# Access Compliance Report

## Public Rights-of-Way

### (Pedestrian Signals)

Intersection ID: N/A	Main Street:	Cross Street: N/A	Location: N/A
ADA ID: 94C09D9C9BA9	Signal Type: One Push Button-Non APS	Overall Compliance: No	Severity Score: BTN 1: N/A BTN 2: N/A No BTN: N/A
Codes/Mitigation Info/Possible Solution		Field Measurements/Component Compliance

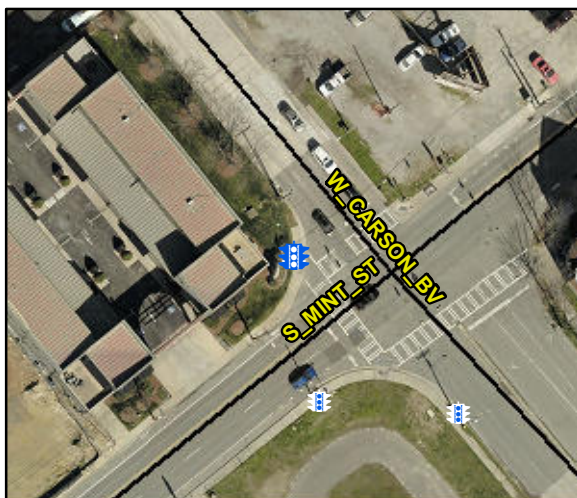
PROW/ADA: TMUTCD 4e.08, R404.1, R404.7.3

Possible Solutions: Replace Signal Push Button With APS Button on New Post. Remove & Relocate Sign.
